# Product Change Notification (PCN)

PCN Number	503090	Date Issued	July 17, 2017
Reason for Change	Change to Product		
Change Type Description	This letter is to inform you that changes are being made to the part(s) identified in this Notice. The change may affect the fit, form, function or appearance of the parts, or it may result in a change to the specification. The pictures below show an example of the possible differences.		
Reason for Short Notice	Special Request		
Assessment of Change	Product will be fully qualified before it is shipped. Qualification reports are available upon request.		
Internal Molex Qualification Date	July 21, 2017		
Sample Availability Date (Changed Part)	July 21, 2017		
Planned Implementation Date	July 28, 2017		
Method of Identifying Change	Lot information on label

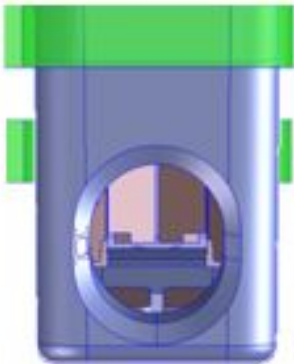
Wire insertion hole size will be larger.
